Access Compliance Report

Public Rights-of-Way

Intersection ID: 51371	Main Street: UNIVERSITY_POINTE_BV	Cross Street: N_TRYON_ST	Location: SW
ADA ID: BD9A75B20643	Ramp Type: Perp	Initial Pass/Fail: Fail	Overall Compliance: No
Severity Score: 10			
Codes/Mitigation Info/Possible Solution		Field Measurements/Component Compliance

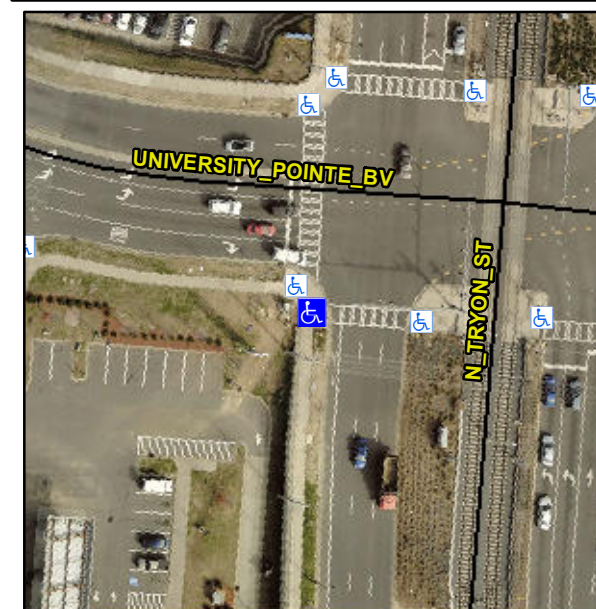
Not Found, R304.5.1, R304.5.3

Compliance	Description	Data	Compliance	Description	Data
N/A	Ramp Length (in)	85.0	Yes	Ramp Slope (%)	6.7
No	Ramp Width (in)	43.5	No	Ramp XSlope (%)	4.7
N/A	Flare Type LT	N/A	N/A	Flare Type RT	N/A
N/A	Flare Slope LT (%)	N/A	N/A	Flare Slope RT (%)	N/A
N/A	Flare Traversable LT?	N/A	N/A	Flare Traversable RT?	N/A
N/A	Landing Length (in)	N/A	N/A	DWS Provided?	N/A
N/A	Landing Width (in)	N/A	N/A	DWS Contrast?	N/A
N/A	Landing Slope (%)	N/A	N/A	DWS Length (in)	N/A
N/A	Landing X Slope (%)	N/A	N/A	DWS Full Width?	N/A
N/A	Landing Curb? (Y/N)	N/A	N/A	DWS Offset (in)	N/A
N/A	Shared Landing?	N/A			
N/A	Gutter Ponding?	N/A	N/A	Gutter Slope (%)	N/A
N/A	Gutter Lip Ht (in)	N/A	N/A	Gutter X Slope (%)	N/A
N/A	Painted X Walk1?	Yes	N/A	Painted X Walk2?	N/A
	X Walk 1 Direction	To E		X Walk 2 Direction	N/A
N/A	X Walk 1 Width (in)	110.0	N/A	X Walk 2 Width (in)	N/A
	X Walk 1 Slope (%)	2.4		X Walk 2 Slope (%)	N/A
	X Walk 1 X Slope (%)	1.4		X Walk 2 X Slope (%)	N/A

Remove & Replace Entire Ramp.
